Enderby, Blaby – Warren Park Way/ Mill Hill Junction – Stage 1 Road Safety Audit – Designers Response

LAND SOUTH OF LEICESTER LANE, ENDERBY, LEICESTER

Warren Park Way/B582 Junction Highway Improvements

Road Safety Audit - Stage 1

Title WARREN PARK WAY / B582 JUNCTION HIGHWAY IMPROVEMENTS - SWEEPED PATHS

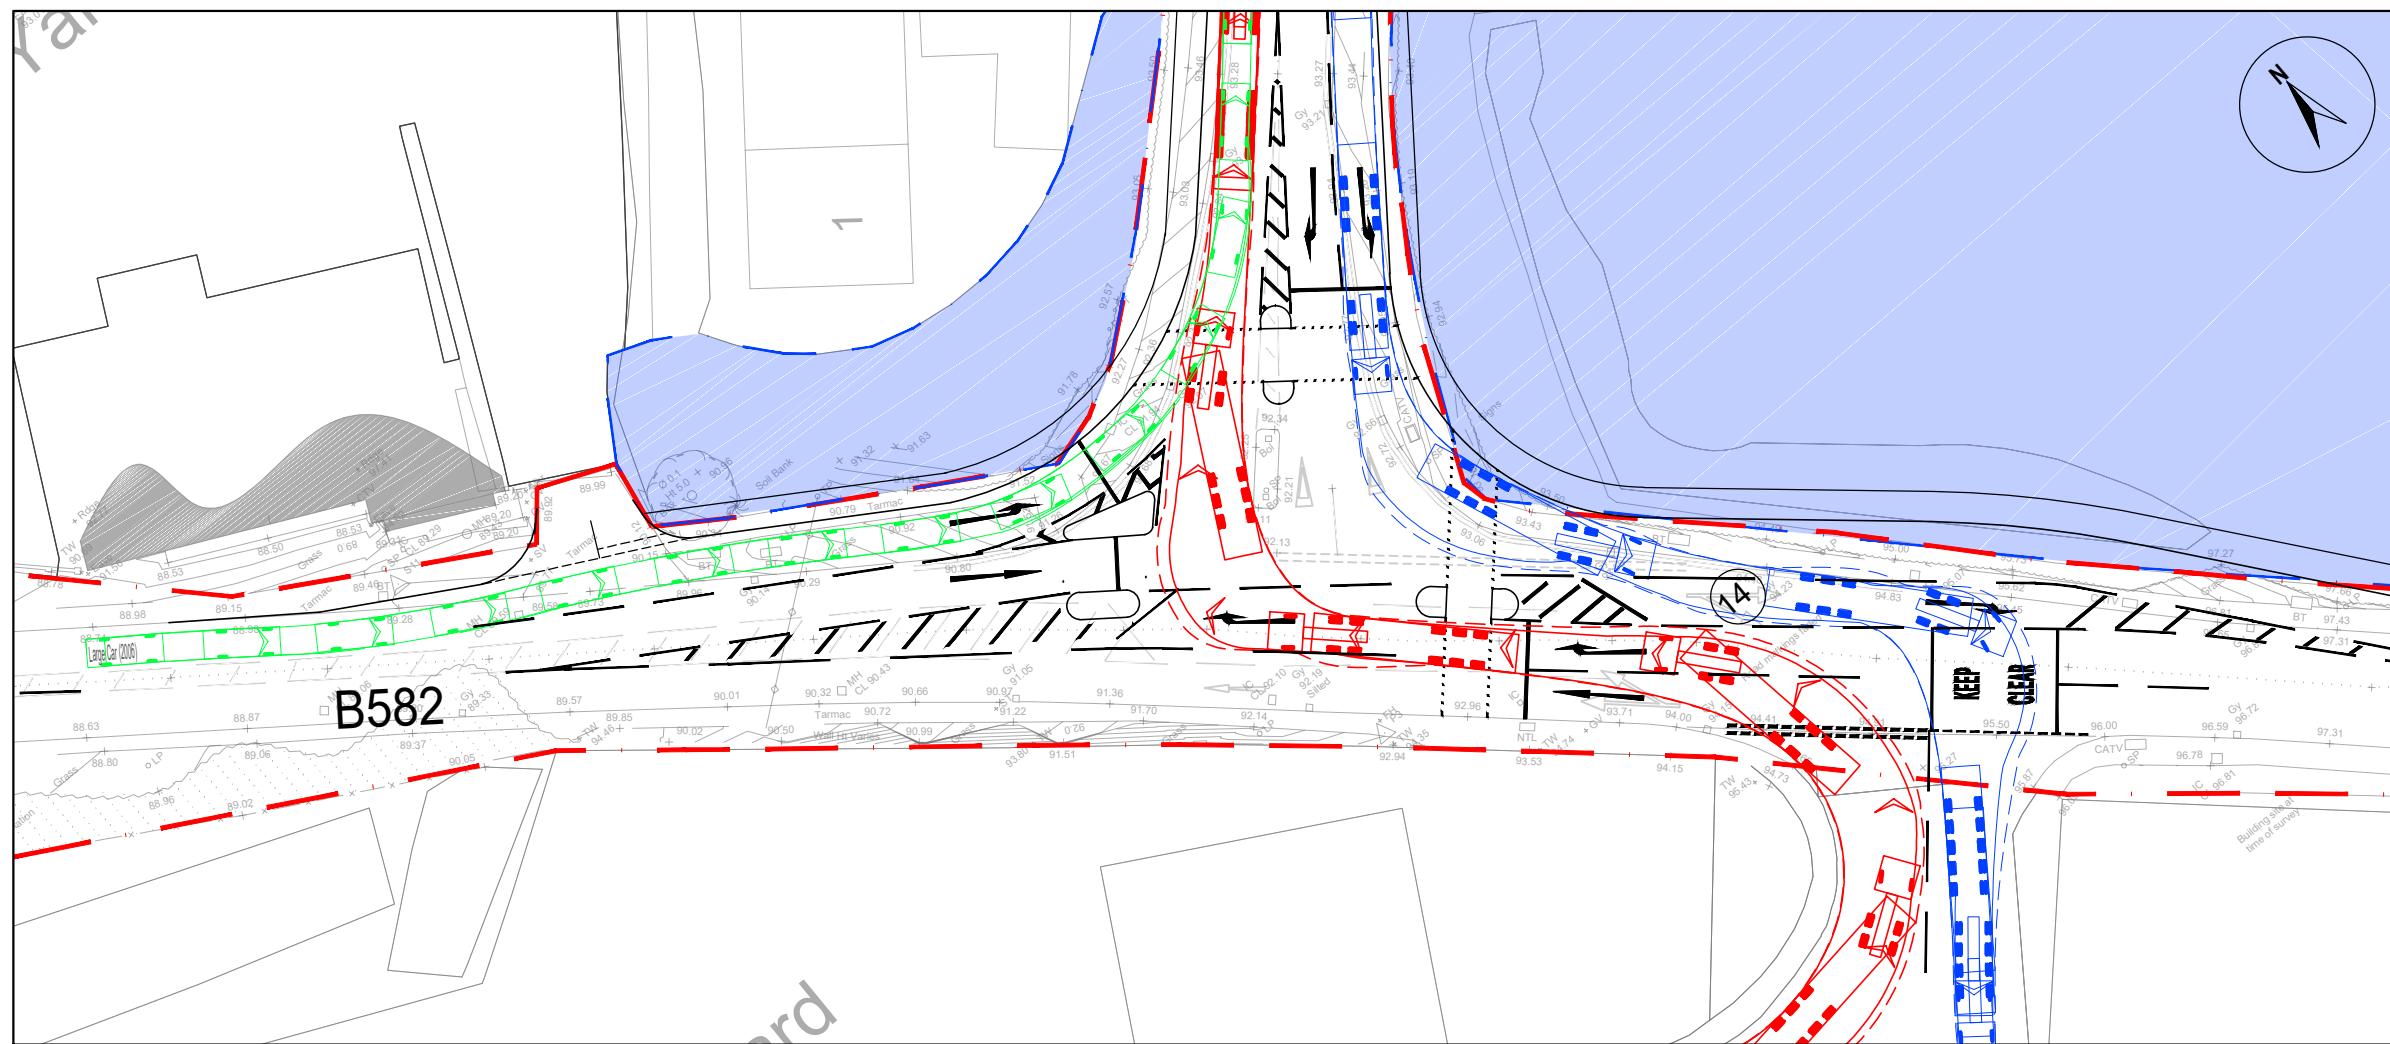
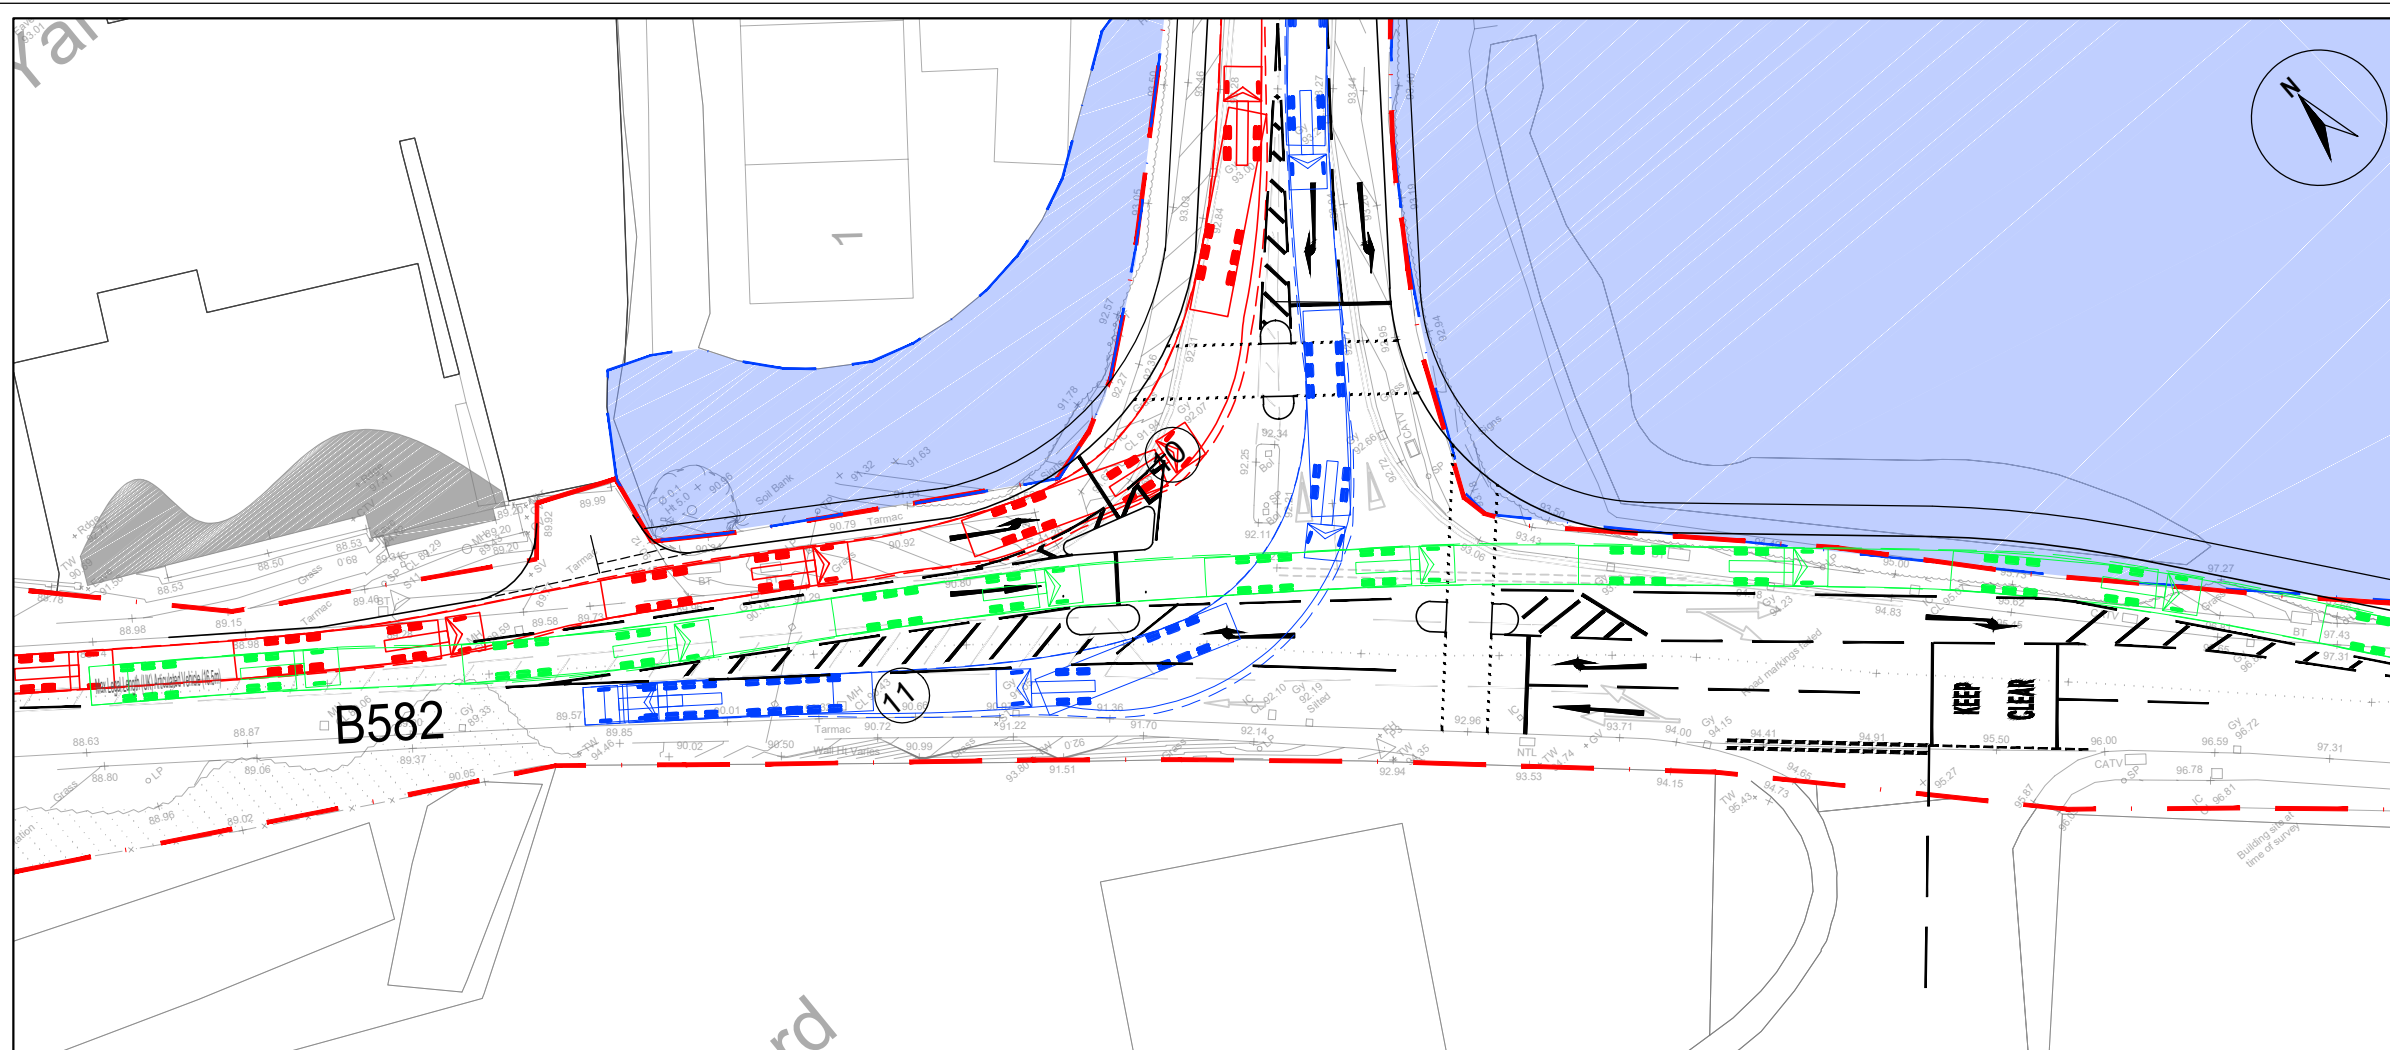
Detail - The Vehicle Swept Paths for HGV's turning right from Warren Park Way into the B582 appear to be extremely tight confirming that the vehicle body path touches the splitter island to the west of Warren Park Way. This may increase the risk of vehicle to street furniture type collisions.

The Audit Team recommends that the turning movements of HGV's can be safely accommodated without hitting street furniture on the splitter islands on the B582.

2.2.2	<p>Summary: Insufficient width to accommodate Heavy Goods Vehicles (HGV's) Right Turning movements into B582</p> <p>Detail: The Vehicle Swept Paths for HGV's turning right from Warren Park Way into the B582 appear to be extremely tight confirming that the vehicle body path touches the splitter island to the west of Warren Park Way. This may increase the risk of vehicle to street furniture type-collisions.</p> <p>Recommendation: The Audit Team recommends that the turning movements of HGV's can be safely accommodated without hitting street furniture on the splitter islands on the B582.</p>	<p>Recommendation Accepted.</p> <p>The tracking shows that a max legal can safely manouvre through the junction without affecting the traffic islands, however to allow more room for large vehicle turning right from Warren Park Way, the island width has been reduced from 2m to 1.8m, this is a traffic island and will not accommodate pedestrian movements therefore this is considered acceptable. This ensures that there is 0.5m between the body of the vehicle and the island.</p>

Problem Location Plan

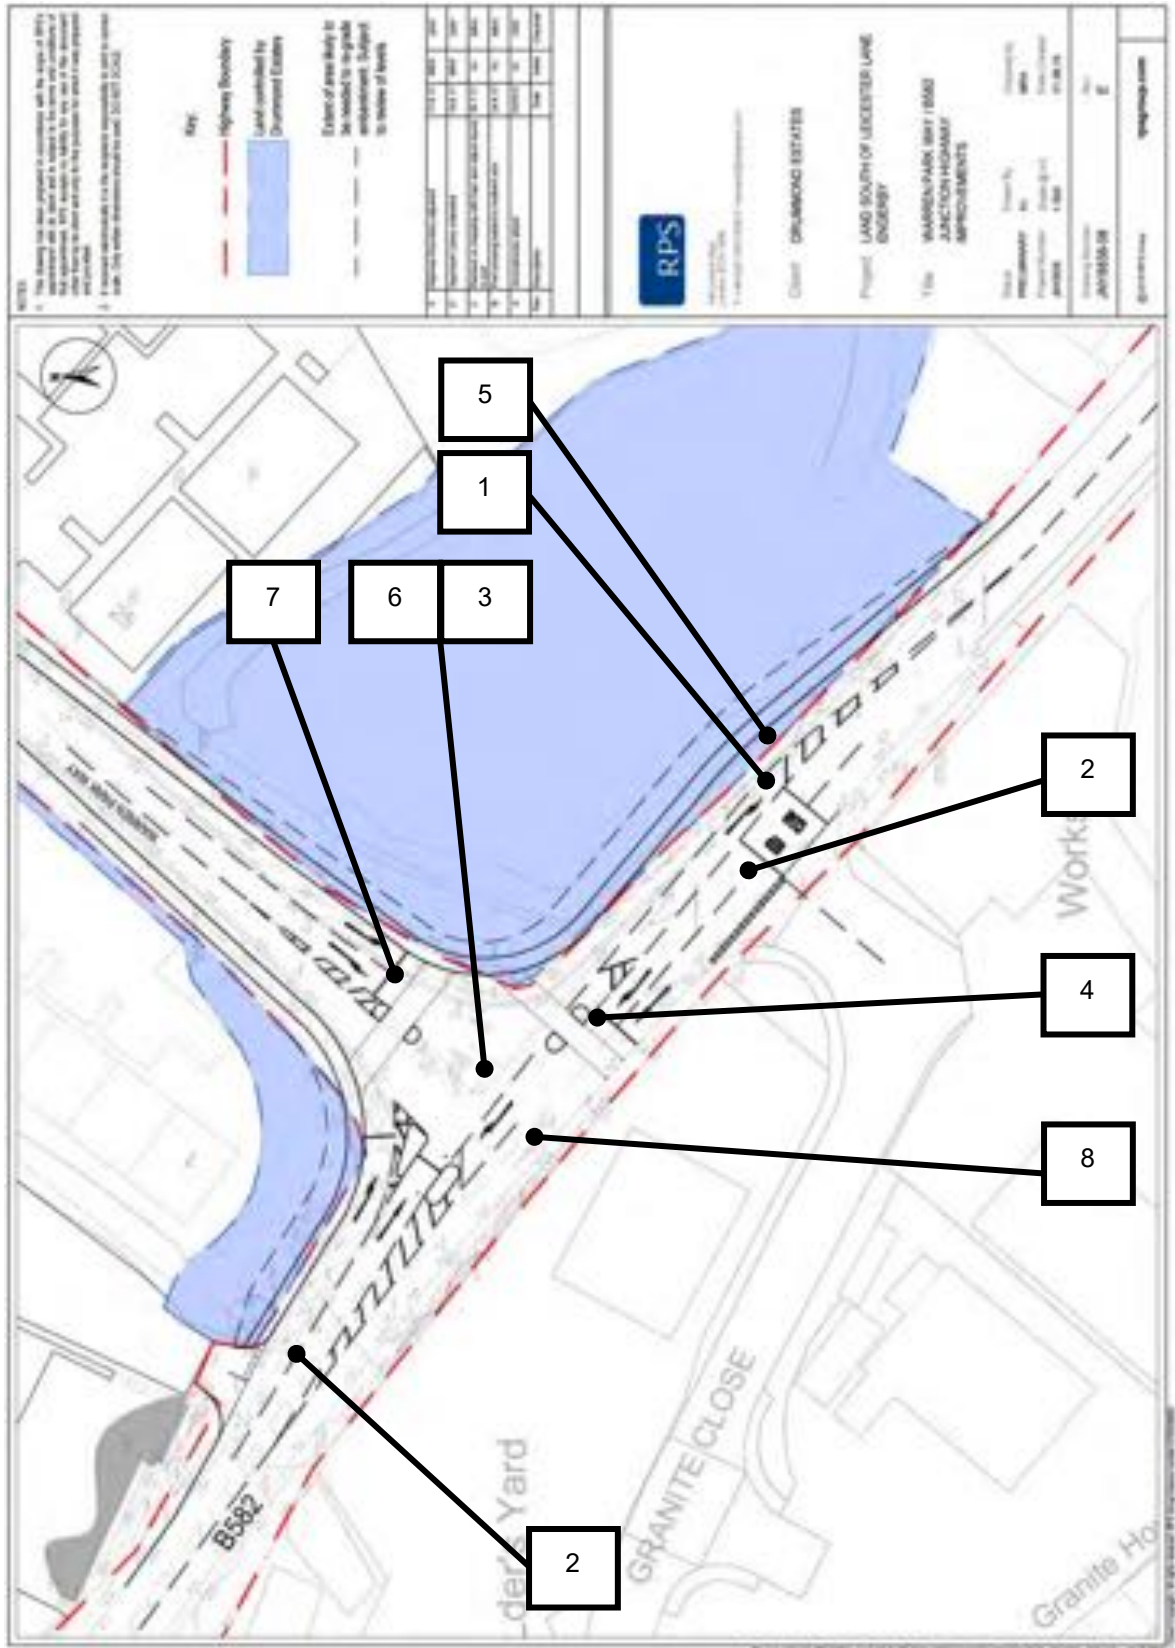
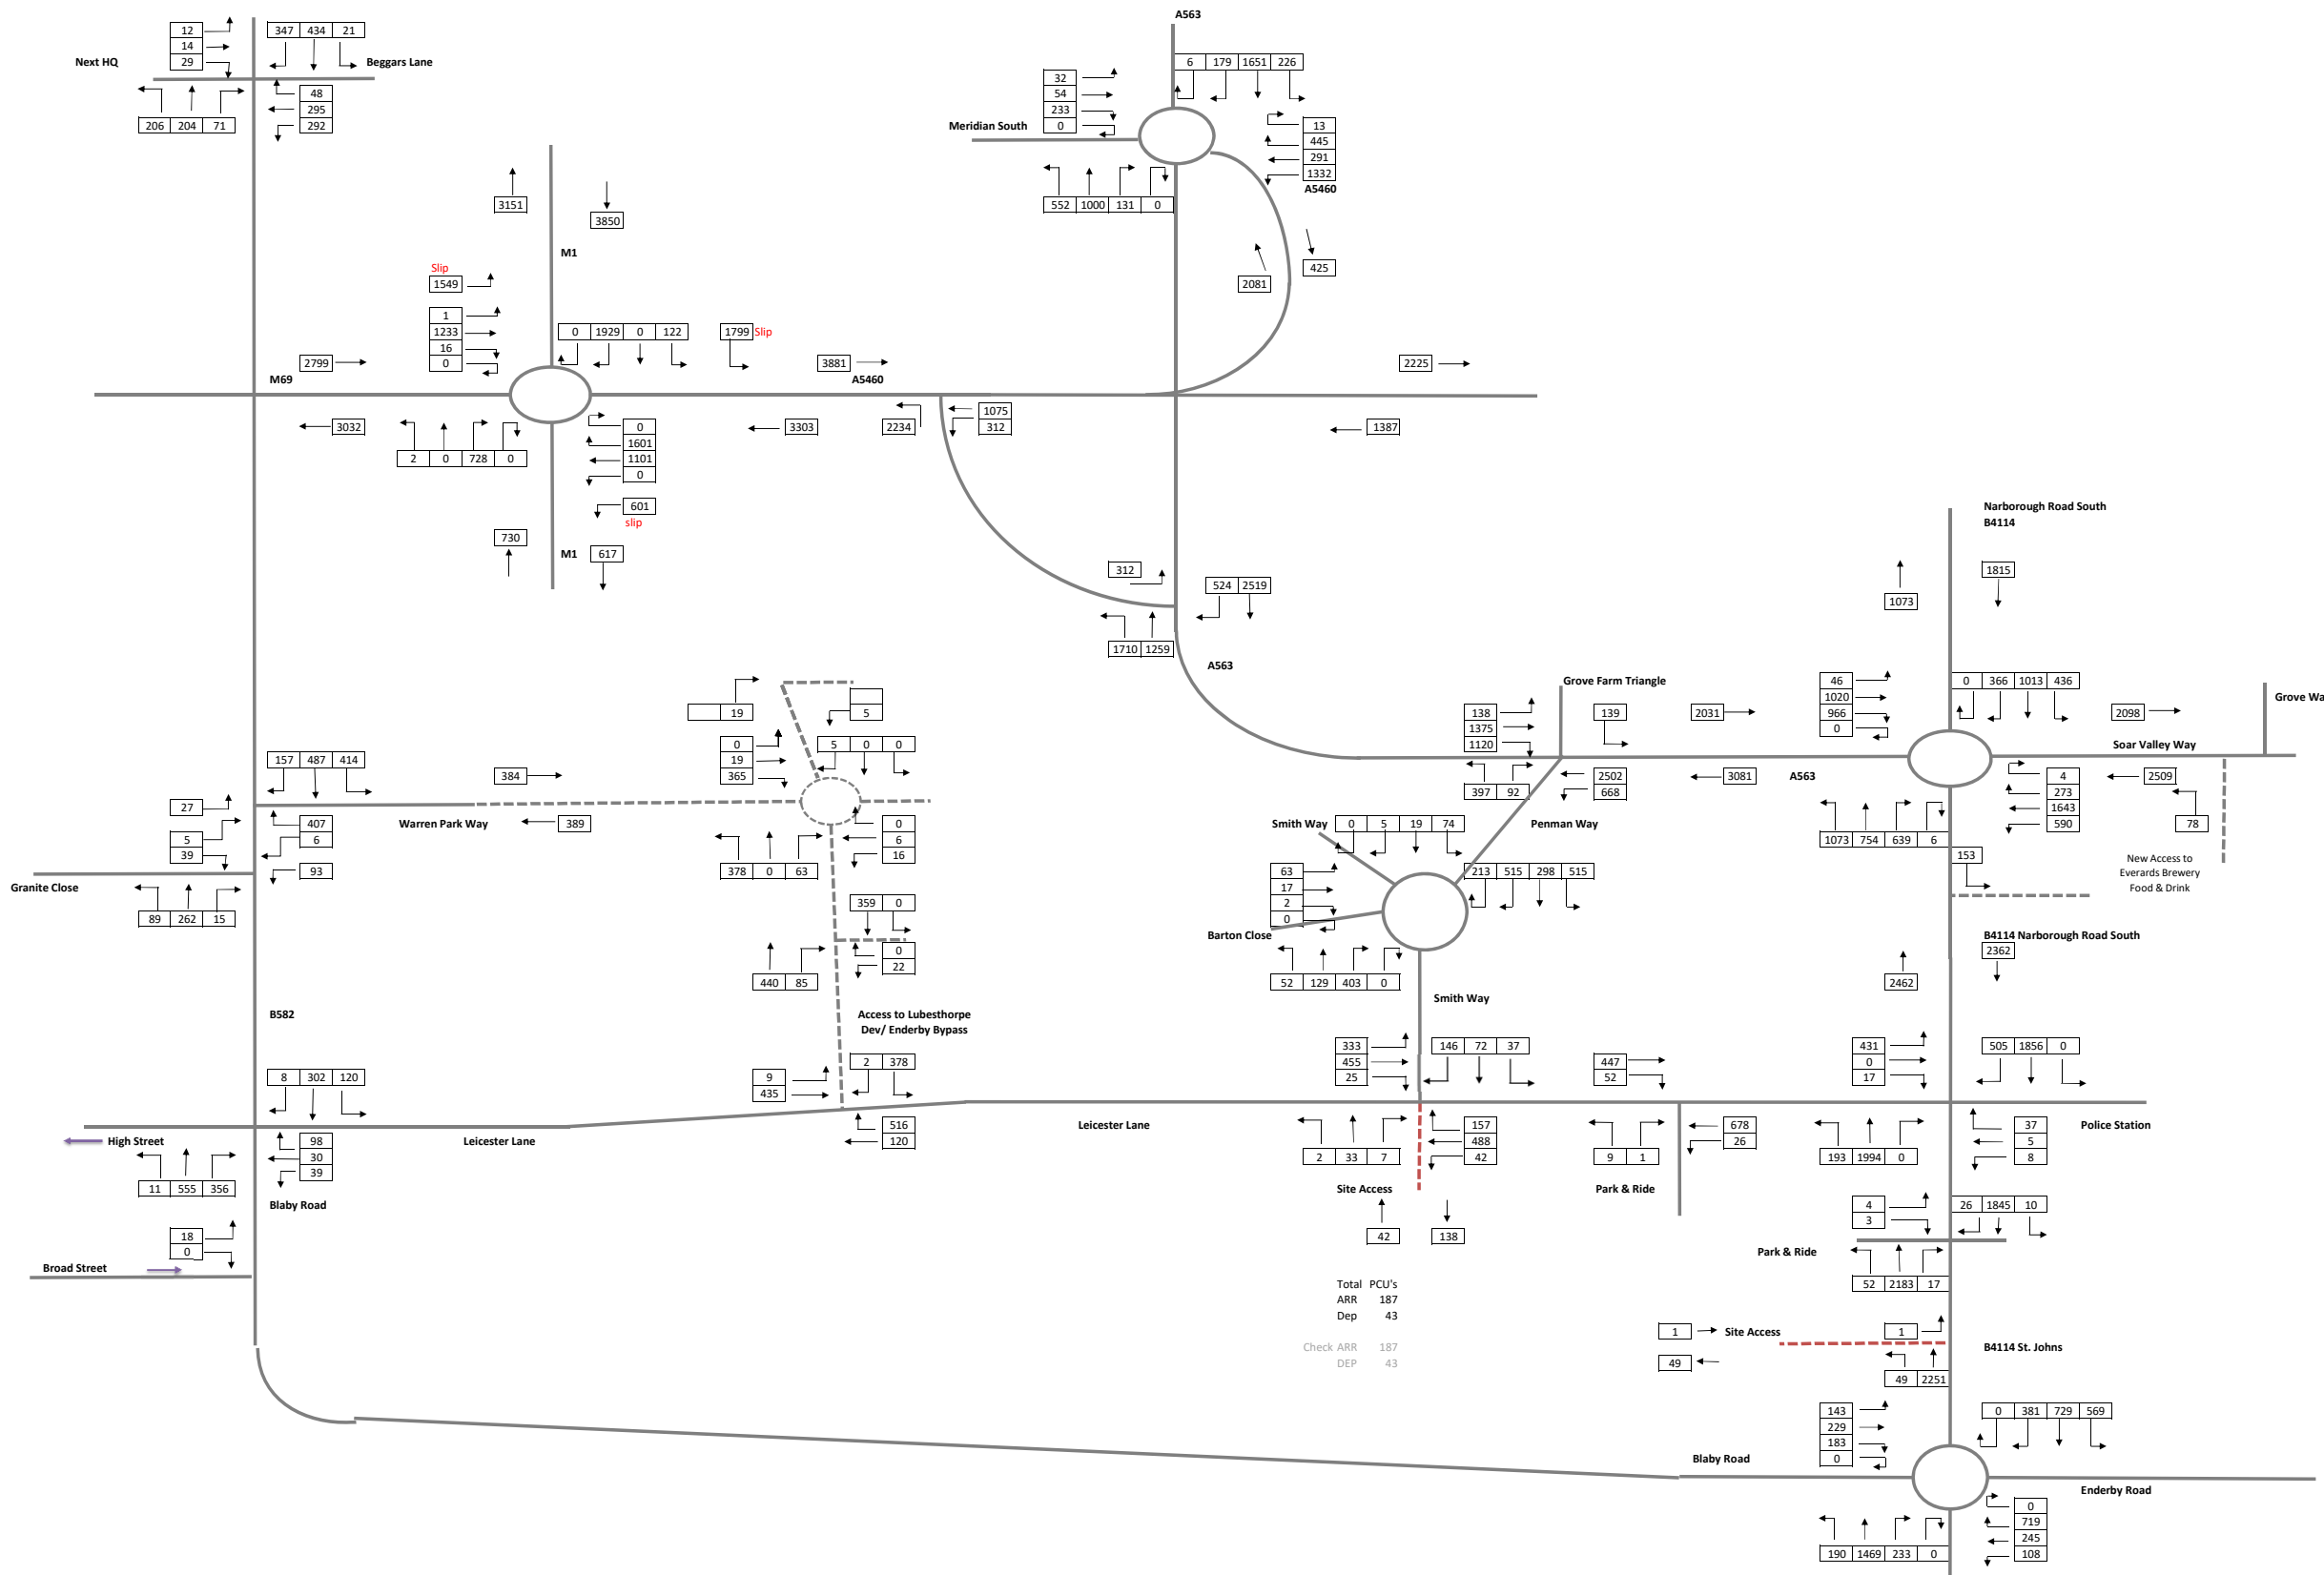
All Problems and Recommendations are referenced to the design drawings and the locations have been indicated on the A4 plan supplied for use by the Audit Team in **Appendix B**.
